Subject: Technical Specification Change Request No. 317 – Deletion of Reactor Building Purge Air Treatment System Technical Specification Requirements

Three Mile Island, Unit 1 (TMI Unit 1) Facility Operating License No. DPR-50 NRC Docket No. 50-289

Markup of Proposed Technical Specification Page Changes

3.15.2 REACTOR BUILDING PURGE AIR TREATMENT SYSTEM

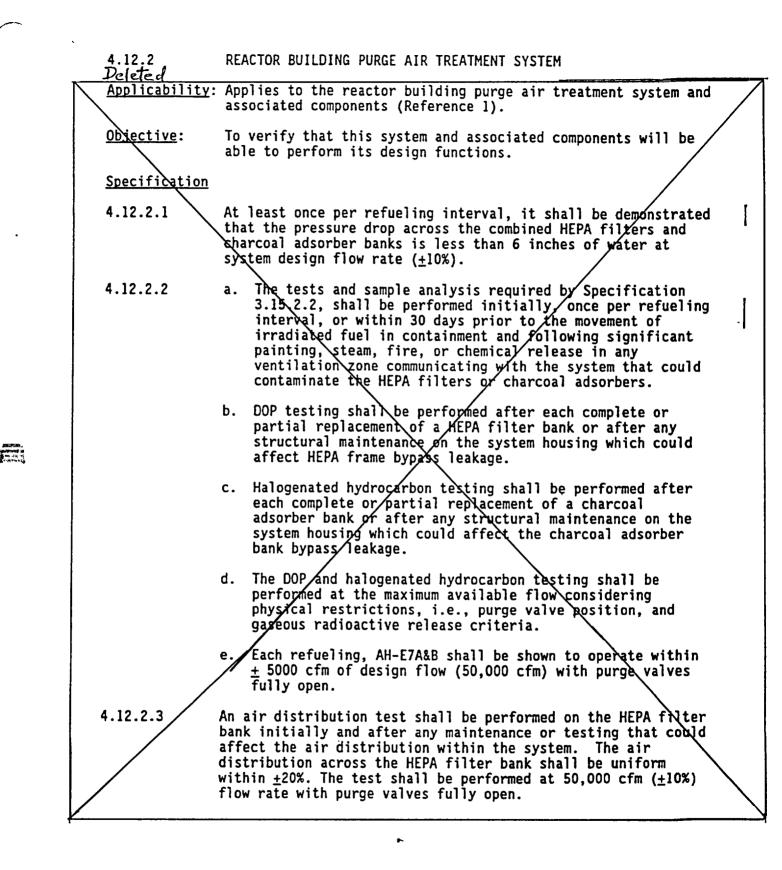
DELETE THIS PAGE IN ENTIRETY

The flow through AH-F1 can vary from 0 CFM to 50,000 CFM, the maximum purge flow rate During all modes except COLD SHUTDOWN, the purge valves are limited to no more than 30° open (90° being full open). This provides greater assurance of containment isolation dependability per NUREG 0/37 Item II.E.4.2 Attachment 1 Item (2)(a). Makeup air is provided between the filter AH-F1 and the fans AH-E7A and B. (See also T.S. 3.6).
